Project	Proposed Solar Farm and BESS – Land off Main Road, Kelham, Nottinghamshire	Document No	153626-005-03
Subject	Technical Note – Response to Consultation Responses from Nottinghamshire County Council Highways and National Highways

Overview

Nottinghamshire County Council Highways Consultation Response 31/10/2023

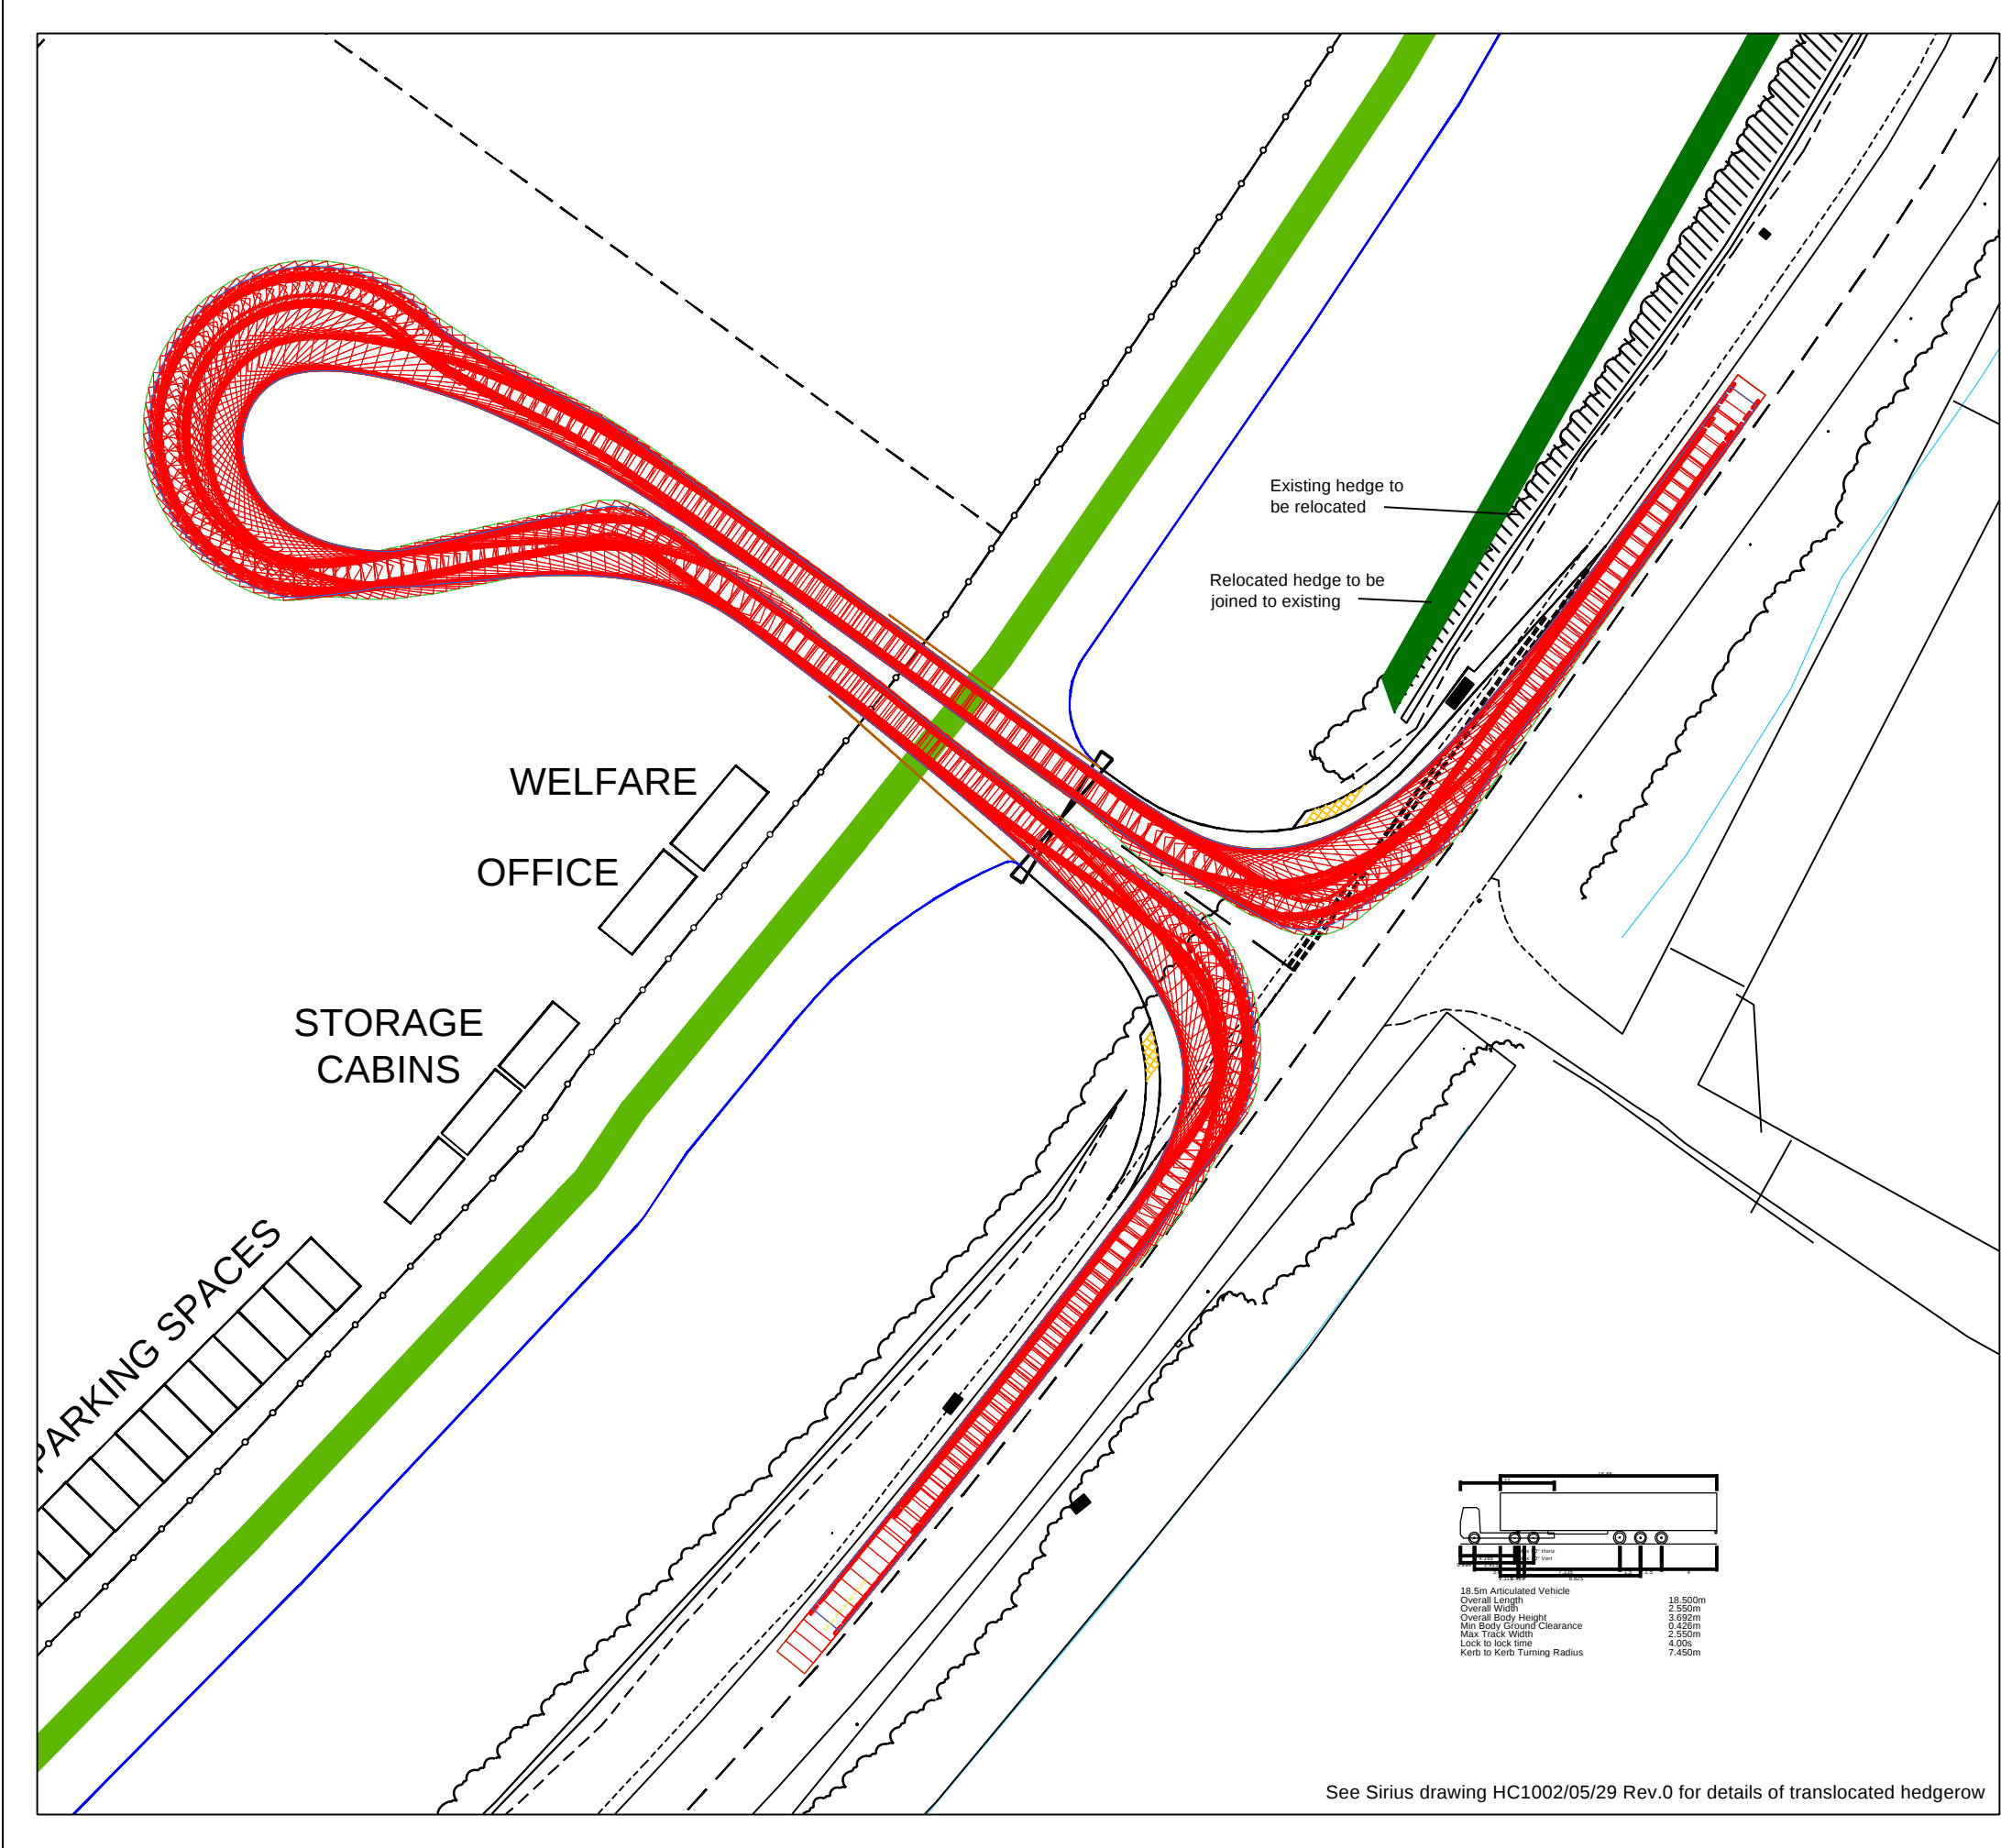
- Provide swept path analysis of bends on A617
- Update accident analysis to include 2022 data and 2023 where possible

Conditions at the bends on the A617 at Kelham are of concern and the applicant should consider the impact of the proposed development traffic, particularly HGVs and any abnormal loads, at these locations. Swept path plots to demonstrate that long vehicles can pass each other in opposite directions would be useful at these locations.

Swept path analysis has been undertaken of the bends on the A617 utilising an 18.5m articulated vehicle, see Drawing 153626-007 at Appendix C. This has been carried out on OS data as the only information available at this time. However, it is acknowledged that inaccuracies are inherent within OS data. This is particularly evident on Kelham Bridge which, on Google, appears to have a minimum carriageway width of approximately 5.0m whereas the OS data is showing it at 4.35-4.6m.

It is not possible for two 18.5m vehicles to pass each other at either bend. However, a car can pass the HGV at the western bend. On the eastern bend, a car travelling north/westbound would be able to see an HGV approaching in the opposite direction at a distance of 43m, appropriate for the 30mph speed limit of the road. Although this sight line passes over the bridge wall, the HGV is of such size that it would be clearly visible. The car would then be able to stop and wait, as shown on the drawing, allowing the HGV to pass. Likewise, a car travelling east/southbound would be able to see an HGV approaching, again at a distance of 43m, and could wait on the bridge to allow it to pass (based on the carriageway width being 5.0m, added in blue on the drawing, rather than the narrower width shown on the OS data). It is considered that this is an acceptable arrangement given the average of five deliveries a day associated with the construction of the site.

Scale	1:500	Drawn By	SB
Drawing Size	A3	Checked By	KS
Date	Dec 2023	Approved By	KS
Drawing Number		Rev	
153626-006		A

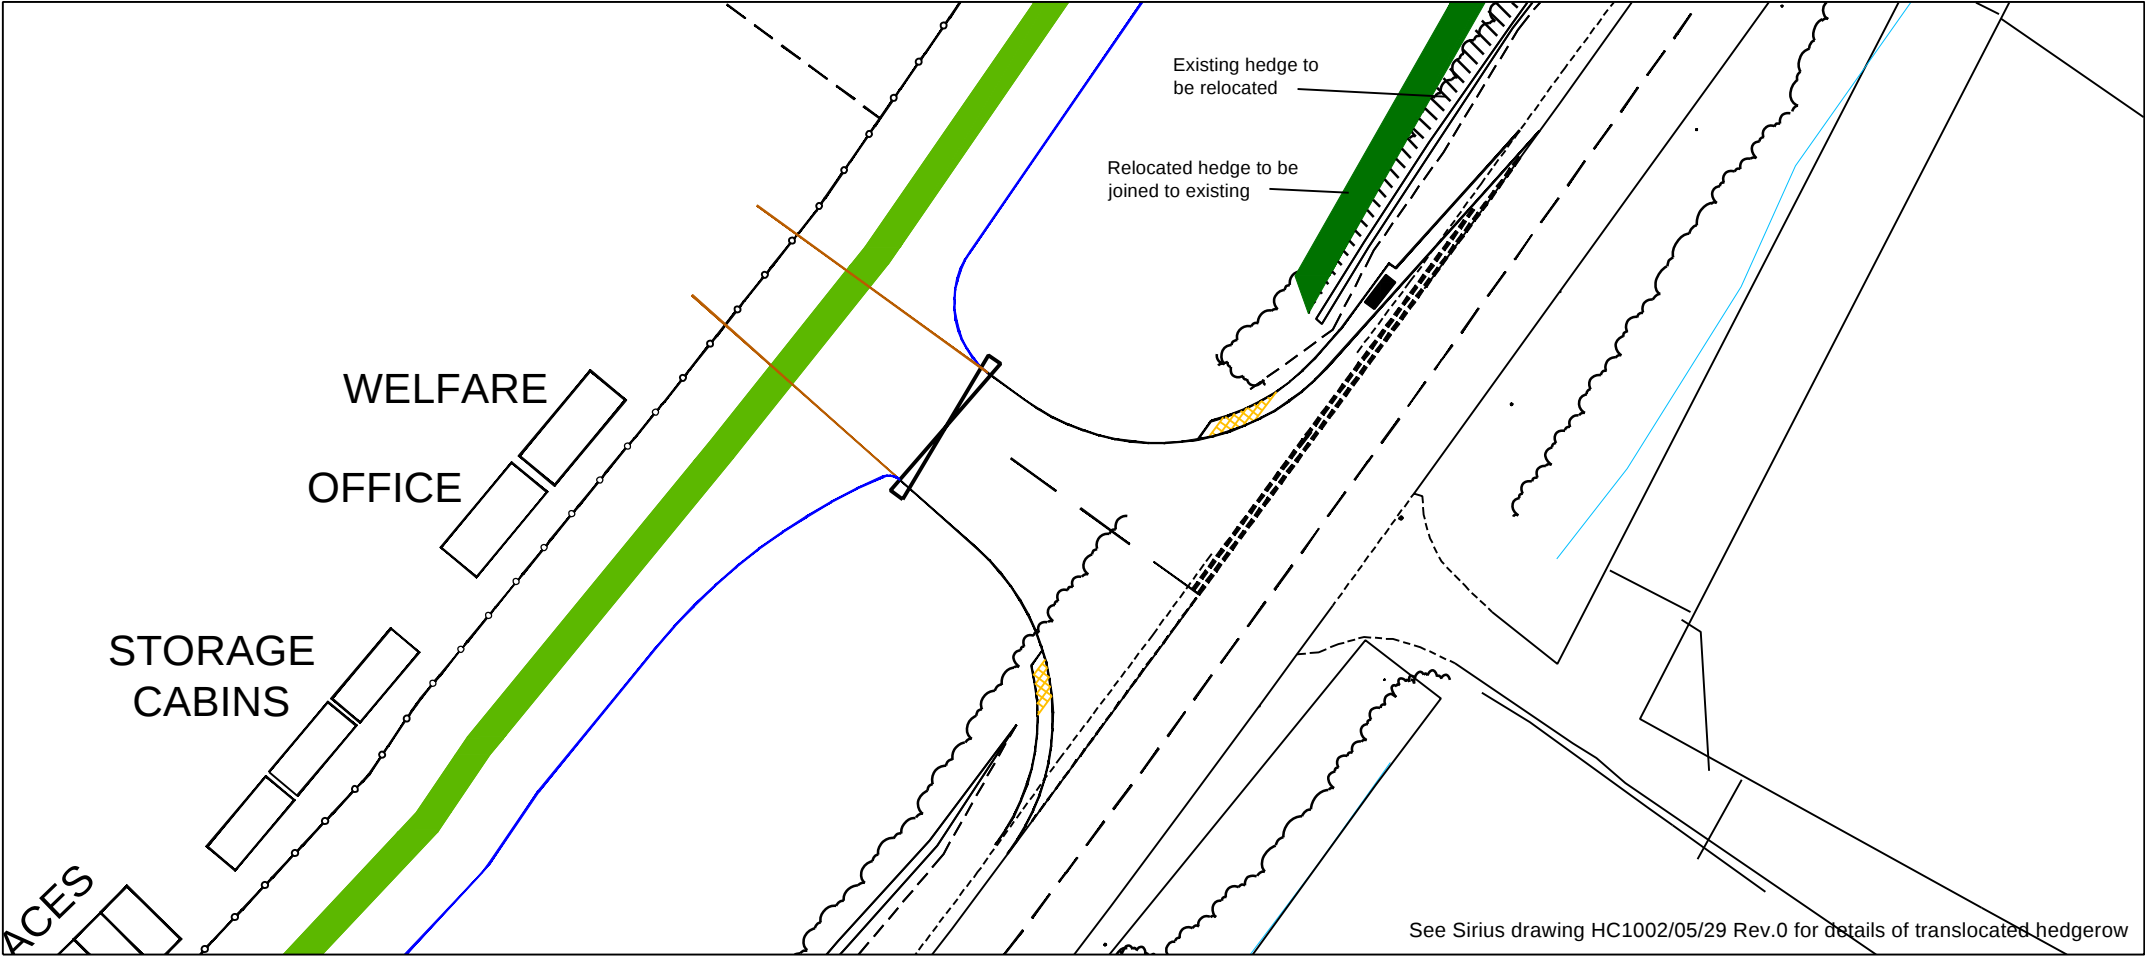
- Provide details to confirm how long vehicles will manoeuvre within the site.

The applicant should provide details which confirm how long vehicles will manoeuvre on the on-site service access tracks and within loading/unloading areas.

Drawing 153626-006 Rev A, attached at Appendix C, demonstrates the vehicle swept path of an 18.5m long articulated vehicle within the set down area. Larger vehicles will all enter this area to unload with plant and materials being transferred to other areas of the site on smaller vehicles.

DRAWN	DATE	APPROVED	DATE
S.T	11/10/2023	J.C	11/10/2023
SCALE	SHEET	DRAWING NUMBER	REVISION
1:1000	A1L	HC1002/05/25	0

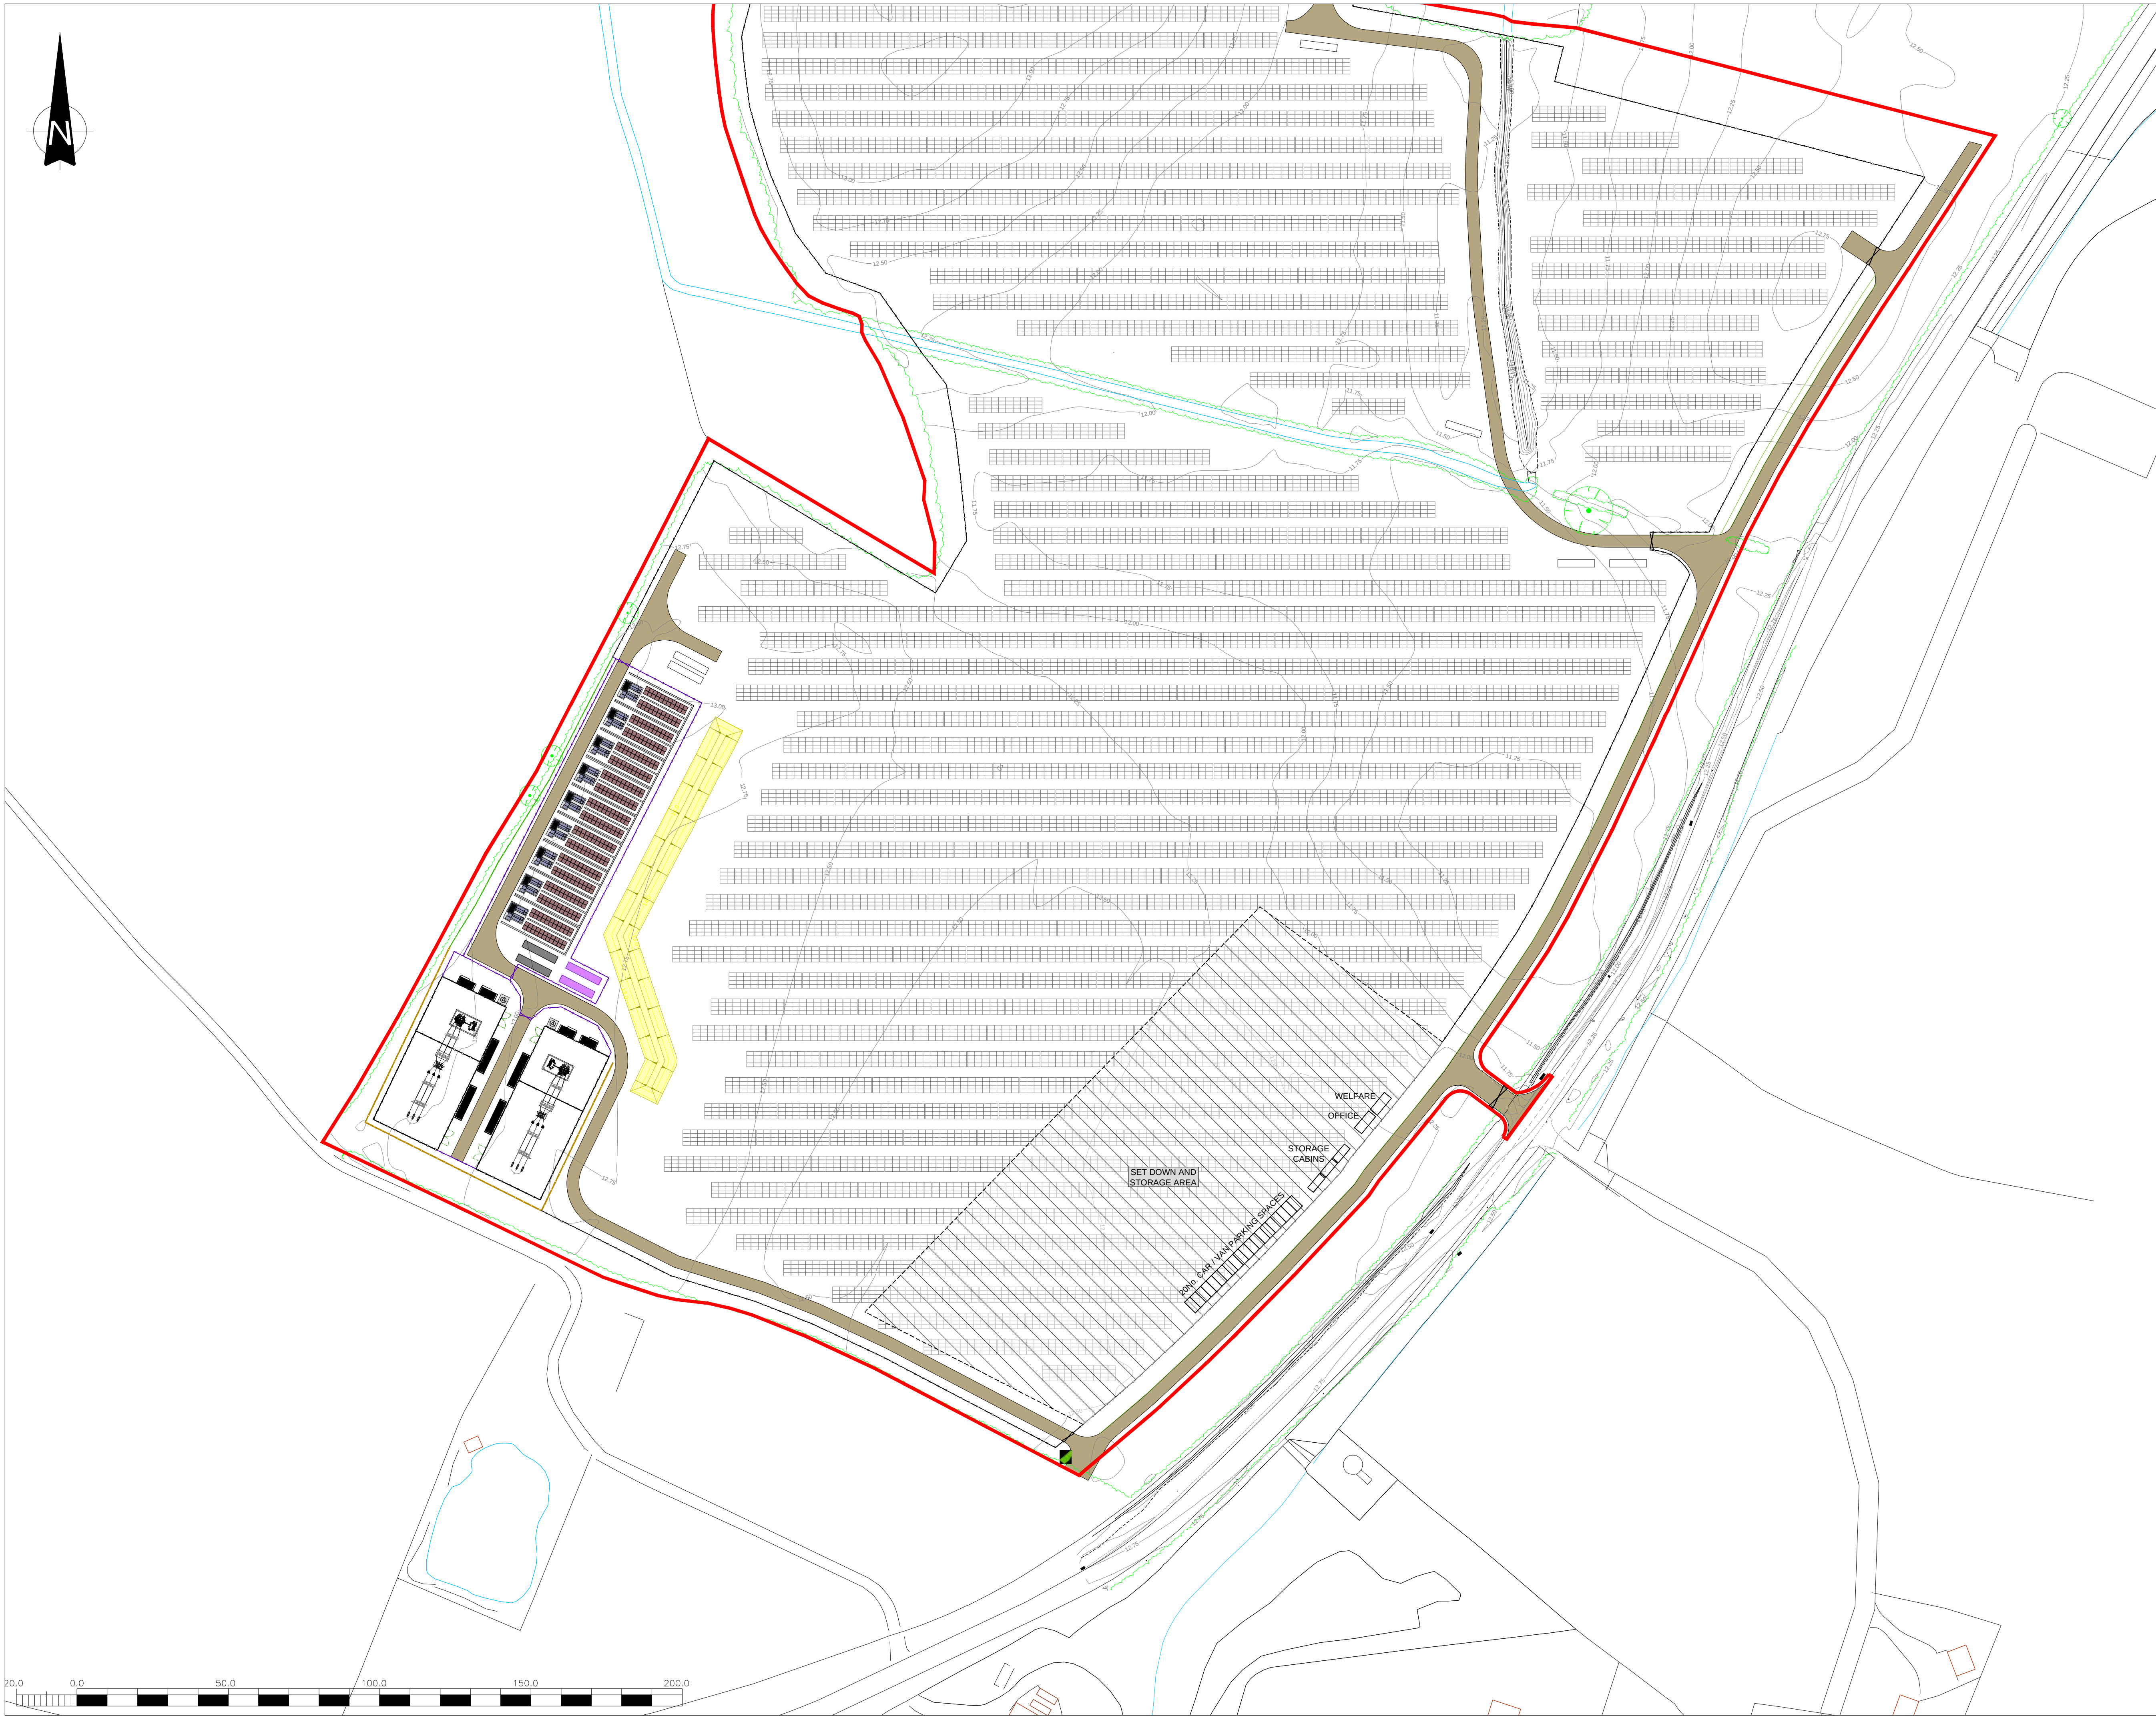
- Confirm arrangements for site construction staff

No proposals are made for parking for site construction staff. Given that most staff would likely arrive by car, on-site parking provision will be needed during the construction phase to prevent on-street parking along the A617 and/or within Kelham and Averham. Details should be provided.

Sirius Drawing HC1002/05/25 Revision 0, attached at Appendix E, shows the parking arrangements within the proposed set down and storage area. A total of 20 car/van parking spaces are proposed within this designated areas along with welfare and office facilities and storage cabins.
